Type Coffee Vending Machine	Model 9100	T.I. NO 02 - 2017	
Serial Number 71211404	Subject Modification of 250VA SWITCHING POWER BOARD	ISSUED FOR (X)	Action Information X

Be informed that with the aim to improve our equipment, the **250 VA switching power board** has been modified.

New
250VA switching power board
Spare part code: **261184**

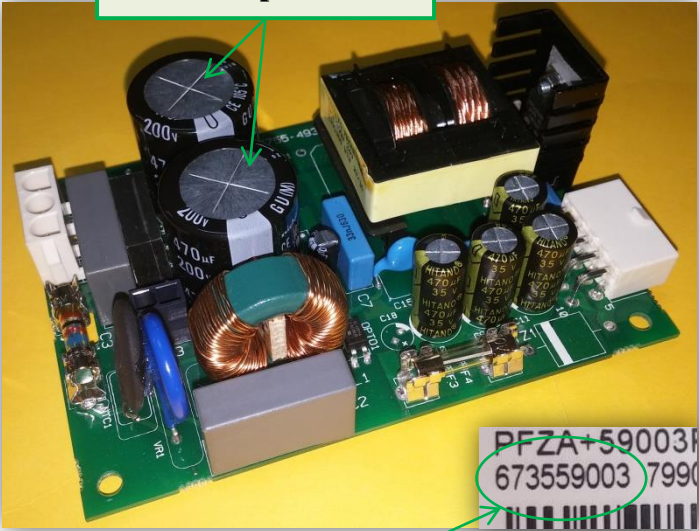
The **two capacitors** have been modified.

New capacitors

Pre-modification capacitors

The *new power board* can be installed in the machines prior to the above mentioned S/N. The *new* 250VA switching power board spare code is: **261184 SAP: 55117441**
